RESPONSE TO REQUEST FOR ADDITIONAL INFORMATION

APR1400 Design Certification

RAI No.: 415-8503

SRP Section: 15.06.05 – Loss of Coolant Accidents Resulting From Spectrum of Postulated Piping Breaks Within the Reactor Coolant Pressure Boundary

Figure 15.06.05-15-1 CEFLASH-4AS Inner Vessel Phase Separation Model.

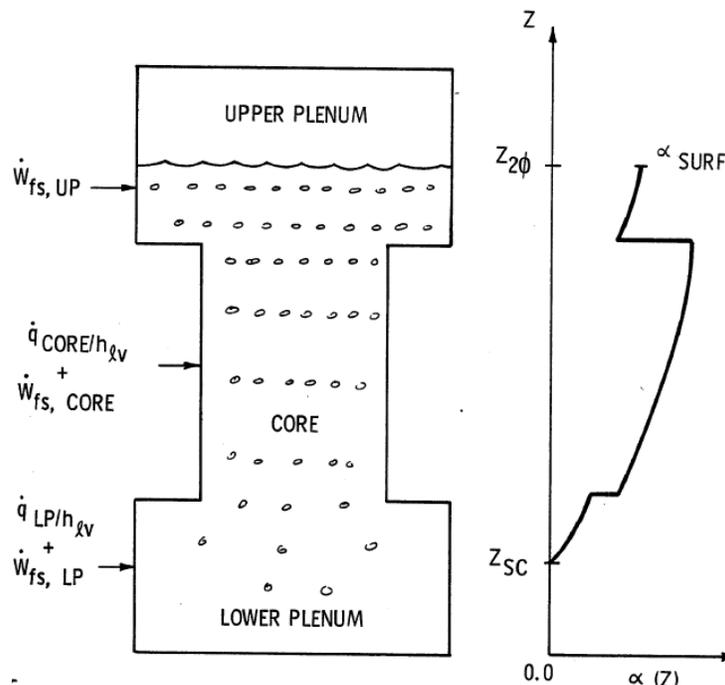
Please explain how the two-phase water level in the core was determined. The applicant needs to provide a clear definition of the two-phase level, and elaborate on any criteria or thresholds involved. Document the assumptions involved in calculating the two-phase water level in the core, and justify combining CEFLASH-4AS and COMPERC-II reflood two-phase levels as a conservative approach. Provide a plot of CEFLASH-4AS and COMPERC-II two-phase levels for a cold leg break which requires an extended period of interpolation between CEFLASH-4AS and COMPERC-II. Identify the time period when interpolation between the CEFLASH-4AS and COMPERC-II 2-phase levels is occurring, and explain what are the two endpoints of the interpolation that are being used to get the final two-phase level

In CENPD-137(page 30~42) the two-phase mixture level is explained in detail. This response is written to summarize the explanation provided in CENPD-137. The total node mixture level is determined using the phase separation model (see Figure 15.06.05-15-1) and the bubble rise model as described below. The bubble rise model in CEFLASH-4AS has been modified to more realistically describe the effects of non-uniform bubble distribution within a node. CEFLASH-4AS computes the dynamic bubble mass from the following expression:

The bubble population distribution using these assumptions is shown in the Figure 15.06.05-15-1.

Figure 15.06.05-17-1. Influence of ECC Injection Model on Annulus Pressure Transient

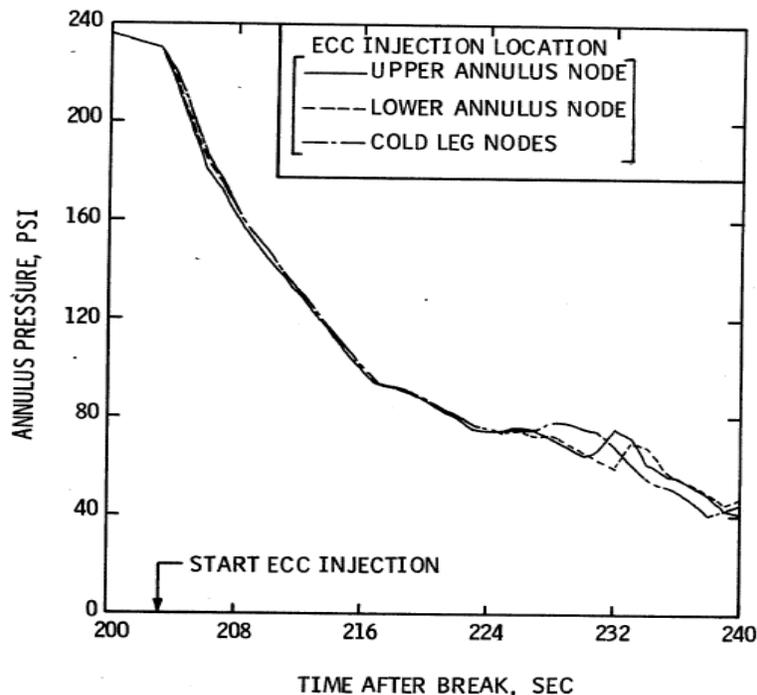
CEFLASH-4AS node diagram in Figure 3.1-1 of the SBLOCA Technical Report (APR1400-F-ANR-14001-P) indicates that the safety injection tank (SIT) and safety injection pump (SIP) flows are injected into the downcomer below the node where the cold legs are connected to the downcomer. The TeR description of Figure 3.1-1 also mentions that the emergency core cooling system (ECCS) is modeled by flow paths connected to the lower annulus. However, the direct vessel injection (DVI) nozzles are actually located in the upper annulus of the APR1400 design, 2.1 m above the cold leg nozzles. Therefore, this simulated arrangement may lead to a non-conservative retention of water in the reactor pressure vessel (RPV) by reducing the amount of ECC bypass. The approved CE-ABB SBLOCA methodology specifies that CEFASH-4AS is to be used until the SITs are activated. Thus, for smaller breaks in the cold leg, there is ample opportunity for the pumped safety injection to be bypassed to the break, an effect which is precluded with the nodalization being employed in the CEFASH-4AS model. It appears that the applicant's depicted methodology provides no mechanism for the ECCS injection water to be ejected out of the break, and thus, may be non-conservative in this regard. Please demonstrate that placing the DVI nozzles in the lower annulus instead of the upper annulus, where they are physically located, results in a conservative or realistic treatment of ECCS injection in the CEFASH-4AS simulations for both the DVI line and cold leg breaks. Also describe where the DVI line break and cold leg break nodes are located in the CEFASH-4AS model.

According to the CENPD-137(page 119), a sensitivity study for the three injection locations(upper annulus, lower annulus, and cold leg) was performed in order to determine the influence of injection location in CEFASH-4AS on the calculated annulus pressure

transient. The sensitivity study shows that the pressure transient used for reflood calculations is insensitive to the CEFLASH-4AS ECC injection location (See figure 15.06.05-17-1).
